STRUCTURAL PEER REVIEW STATEMENT

Project Address: 45 Broad Street, New York City, Block #25, Lot #7, 10

**45 Broad Street
Structural Peer Review Report
Foundations**

24 February 2017

Figure 4 – Location of Pressure Slab Reinforcement Checks (FO-100.00)

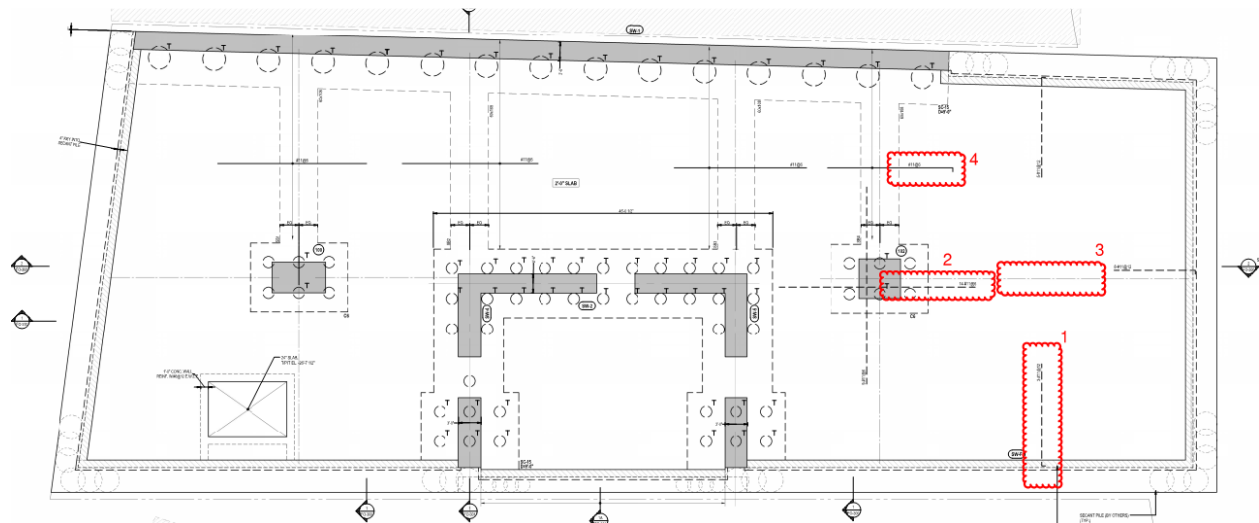
The slab reinforcement of the 24" pressure slabs was checked using the SAFE model described above, using the information provided in the notes on drawing FO-100.00 and additional reinforcement shown in plan. Table 1 below summarizes the findings, while Figure 4 indicates the locations where the capacity of the pressure slab was reviewed.

To address the overstress identified in Table 1, we recommend the EOR revise the design of the pressure slab where it frames into the perimeter wall and to columns 100 and 102 for shear.

Figure 5 – Location of Secant Pile Overstresses

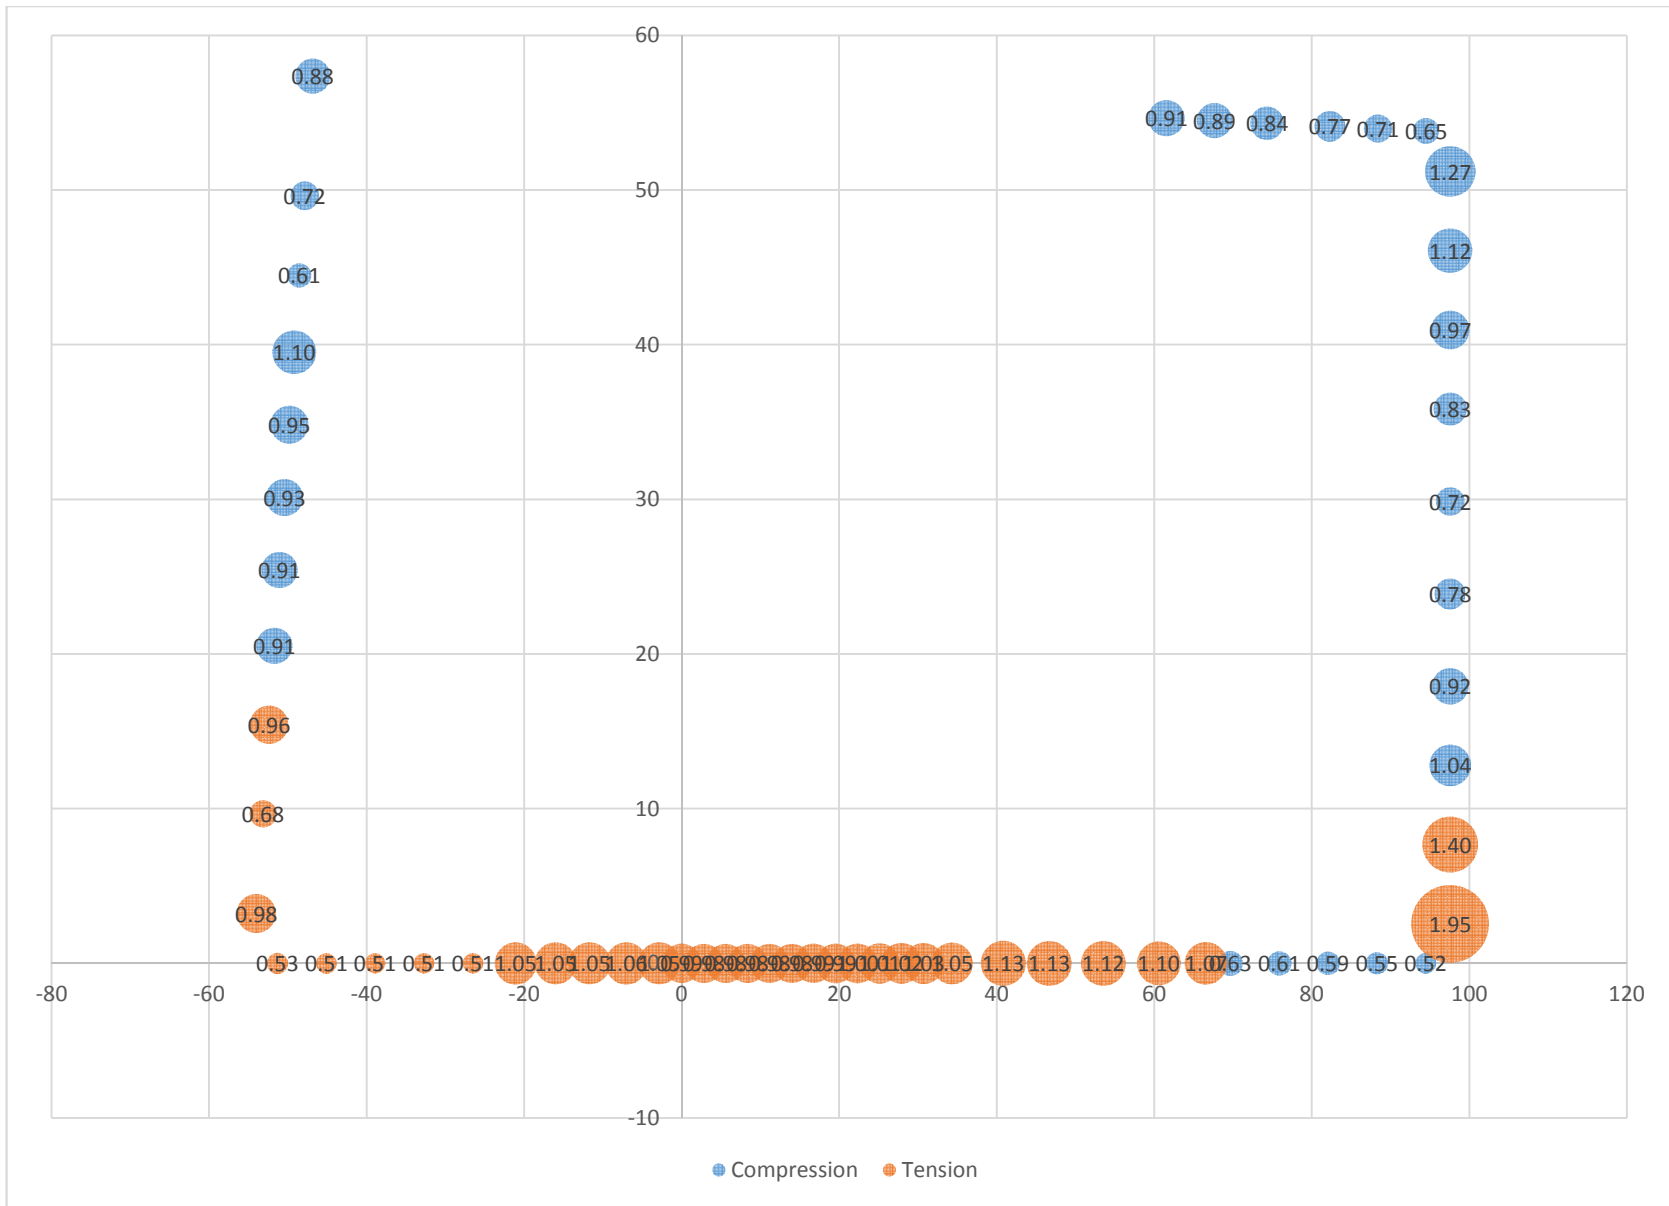
We observed that there are compression and tension overstresses in the secant pile wall under combined gravity and wind loads. We recommend the EOR to revise the secant pile layout to address overstresses.

Figure 6 – Location of Caissons Checked (from FO-100.00)

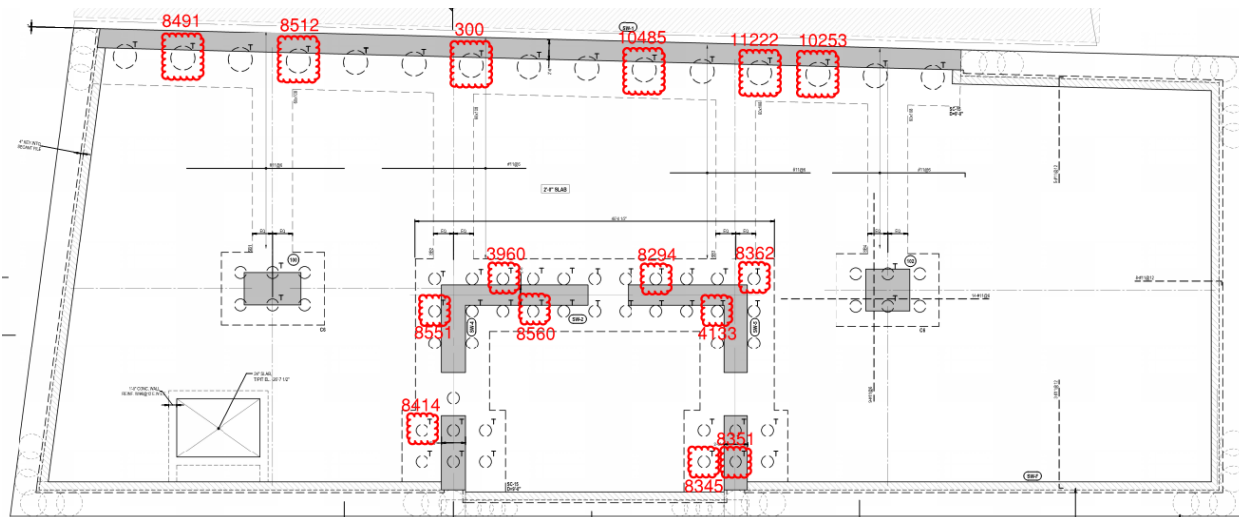
The ETABS model described in Section 3.2 of this report was used to obtain the axial loads in the caissons. The caisson groups shown in plan were reviewed and we found that caisson designs were sufficient for their axial loads. Table 6 below summarizes the finding, while Figure 6 indicates the locations of caissons reviewed.
